Project	IEEE 802.16 Broadband Wireless Access Working Group < <a href="http://ieee802.org/16">http://ieee802.org/16</a> >		
Title	Extension of collaborative spatial multiplexing in OFDMA		
Date Submitted	2005-01-26		
Source(s)	Bin-Chul Ihm, Yongseok Jin, Jinyoung Chun, Kyuhyuk Chung	Voice: 82-31-450-7187 Fax: 82-31-450-7912	
	LG Electronics, Inc. 533, Hoge-1dong, Dongan-gu, Anyang-shi, Kyongki-do, Korea		<a href="mailto:{bcihm, jayjay, jychun03, kyuhuk}@lge.com">[mailto: {bcihm, jayjay, jychun03, kyuhuk} @lge.com]</a>
	<b>Chan-Byoung Chae, Wonil Roh</b> <b>Samsung Electronics Co., Ltd.</b>		<a href="mailto:ch.chae@samsung.com">[mailto: ch.chae@samsung.com]</a>
	Ran Yaniv, Tal Kaitz Alvarion Ltd.		<a href="mailto:{ran.yaniv, tal.kaitz}@alvarion.com">[mailto: {ran.yaniv, tal.kaitz} @alvarion.com]</a>
Re:	This is a response to a Call for Comments on IEEE P802.16e-D5a		
Abstract	The collaborative spatial multiplexing can be applied to the case in OFDMA.

# Extension of Collaborative Spatial Multiplexing in OFDMA

Figure 249a – Pilot Patterns in UL PUSC tile

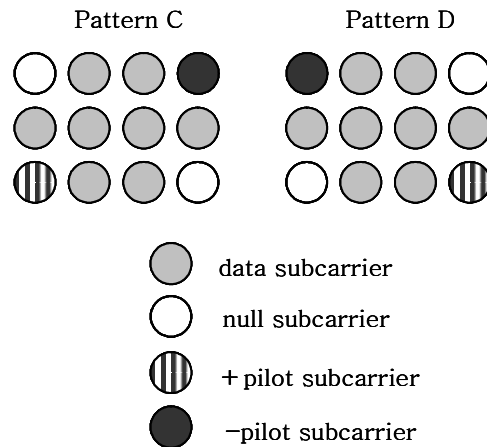
*[Insert Figure 249a after Figure 249 as follows:]*

*[Add text in section 8.4.8.1.5.1 as follows:]*

Two single transmit antenna SS's can perform collaborative spatial multiplexing onto the same subchannel. In this case, the one SS should use the uplink tile with pattern-A and the other SS should use the uplink tile with pattern-B. Also, two dual transmit antenna SS's can perform collaborative spatial multiplexing onto the same subchannel. In this case, the one SS should use the uplink tile with the pilot pattern A, B and the other SS should use the uplink tile with the pilot pattern-C, D through ~~MIMO-UL Basic IE~~ **MIMO UL Enhanced IE**. Pilot patterns are illustrated in the Figure 249 and 249a.
